JOINT REGIONAL PLANNING PANEL (Sydney West Region)

JRPP No	2015SYW105
DA Number	1347/2015/JP
Local Government Area	THE HILLS SHIRE COUNCIL
Proposed Development	THE DEVELOPMENT APPLICATION IS FOR A REVISED MASTERPLAN FOR THE NORWEST TOWN CENTRE EASTERN RESIDENTIAL PRECINCT
Street Address	LOT 2103 DP 1176614 - 38 SOLENT CIRCUIT, BAULKHAM HILLS
Applicant/Owner	MULPHA NORWEST PTY LIMITED
Number of Submissions	THREE (3) SUBMISSIONS RECEIVED
Regional Development Criteria (Schedule 4A of the Act)	GENERAL DEVELOPMENT WITH A CIV OF OVER \$20 MILLION.
List of All Relevant s79C(1)(a) Matters	<p>LIST ALL OF THE RELEVANT <u>ENVIRONMENTAL PLANNING INSTRUMENTS</u>:</p> <ul style="list-style-type: none"> • THE HILLS LOCAL ENVIRONMENTAL PLAN 2012 • STATE ENVIRONMENTAL PLANNING POLICY NO. 65 – DESIGN QUALITY OF RESIDENTIAL FLAT DEVELOPMENT • STATE ENVIRONMENTAL PLANNING POLICY (STATE AND REGIONAL DEVELOPMENT) 2011 • STATE ENVIRONMENTAL PLANNING POLICY NO. 55 – REMEDIATION OF LAND • STATE ENVIRONMENTAL PLANNING POLICY (INFRASTRUCTURE) 2007 <p>LIST ANY RELEVANT DEVELOPMENT CONTROL PLAN: S79C(1)(A)(III)</p> <ul style="list-style-type: none"> • DCP 2012 PART D SECTION 8 – NORWEST RESIDENTIAL PRECINCT •

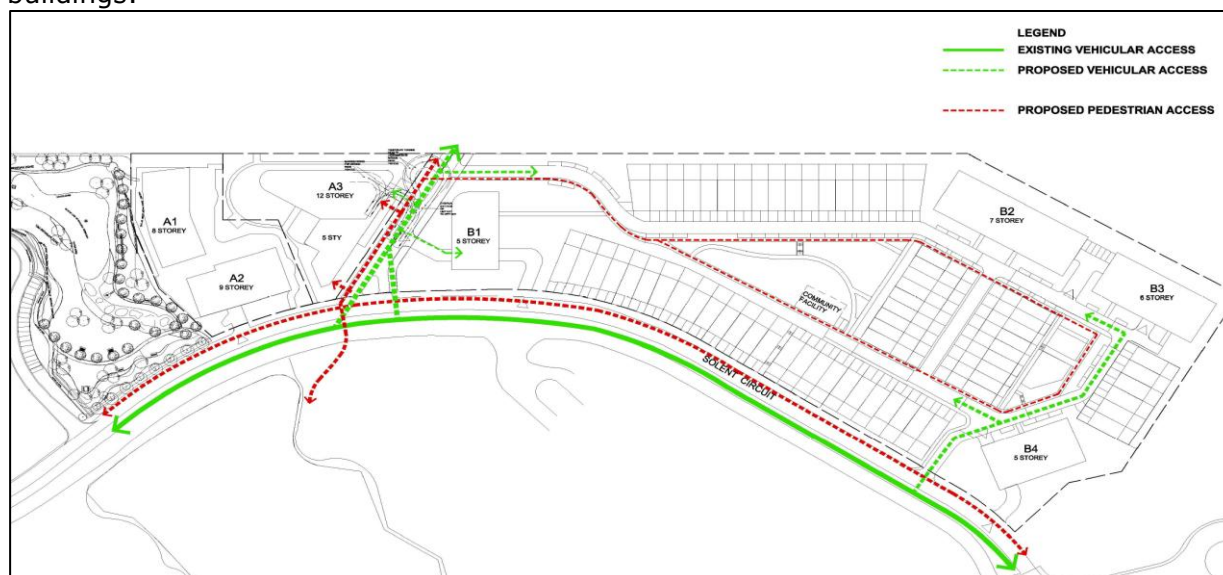
The figure below illustrates the siting and heights of the proposed residential flat buildings:

As illustrated above, the proposal seeks to vary the 5-6 storey height limit across the precinct with Building A3 comprising a maximum height of 12 storeys.

Figure 1

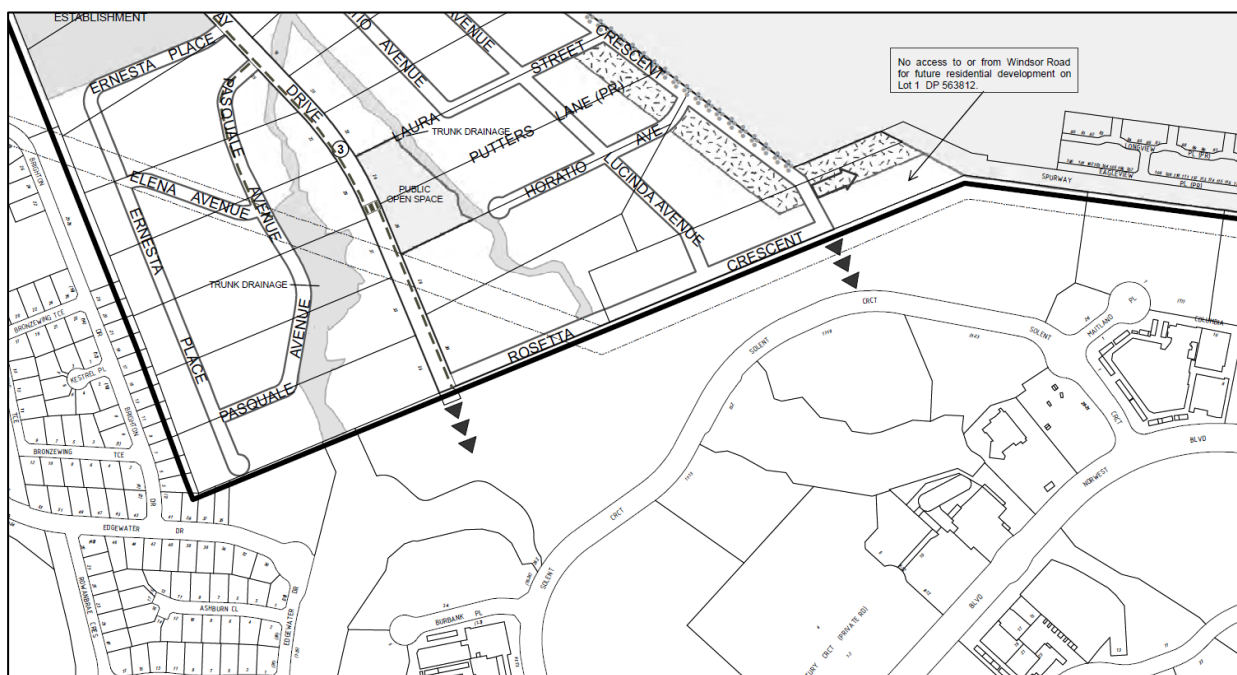
The alignment of the through site link varies from that which was approved under the previous master plan and the DCP. Figures 1 and 2 show the intended road layout proposed in the Balmoral Road Release Area DCP and the Norwest Town Centre Residential DCP.

Figure 3

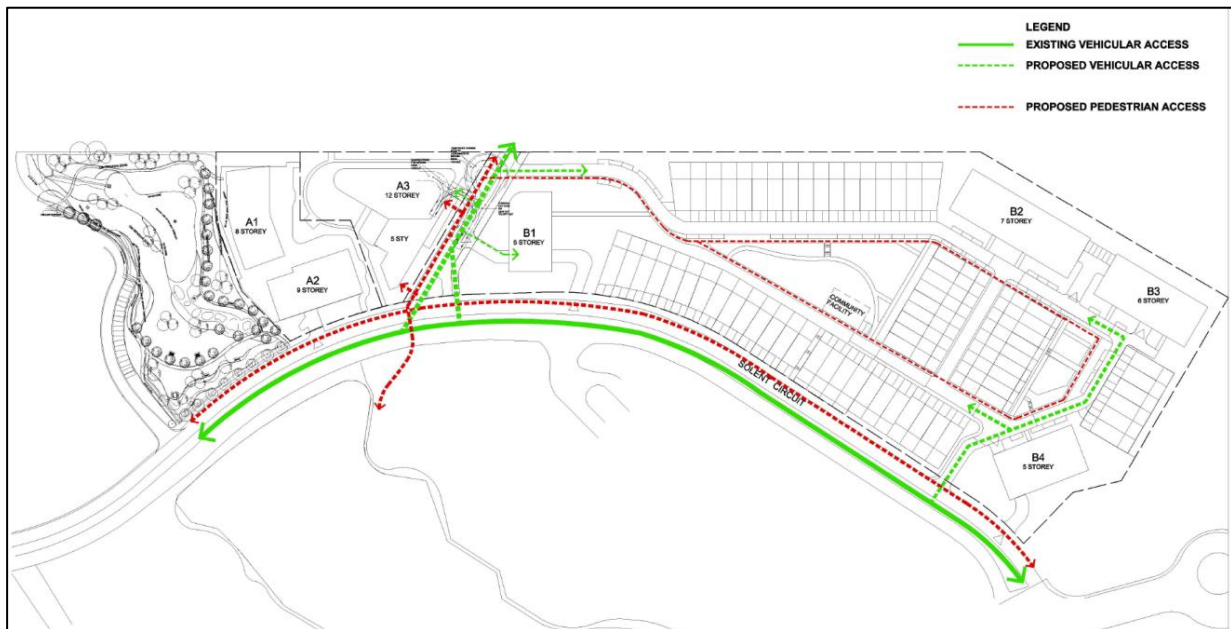
The revised masterplan seeks to realign the through site link as detailed in Figure 3 below:

- *The distances between the proposed T-intersection of the new Link Road and Rosetta Crescent and the two planned T-intersections either side is considered satisfactory from a traffic perspective. The new Link Road intersection is approximately halfway between the future proposed Lucinda Avenue and Rosetta Crescent (as shown in Figure 1 on the following page).*
- *The new Link Road as proposed is a left in, left out type intersection.*
- *The location shown on the Balmoral layout is very steep and road grading is a concern, supporting the proposed location of the new Link Road which is more appropriate to the land form.*

The proposed masterplan comprises a through site link that does not align appropriately with the Balmoral Road Release Area DCP road layout. However, it is noted that Council is in receipt of a concept plan as part of a separate planning proposal for the adjacent site (RMB 47 and Lots 32 and 33 DP 247442, Spurway Drive 10/2013/PLP) that depicts a variation to this DCP road layout that would align with the proposed masterplan (Figure 4).

Moreover, the road alignment has been reviewed by Council's Manager Infrastructure and Transport Planning who raised no objection to the road alignment and the permeability of the street network provided that the approaches were redesigned so as to prevent acute angles at the intersections. Accordingly, the approaches to Solent Circuit and future Spurway Drive have been redesigned in order to provide safer approaches with desirable sightlines.
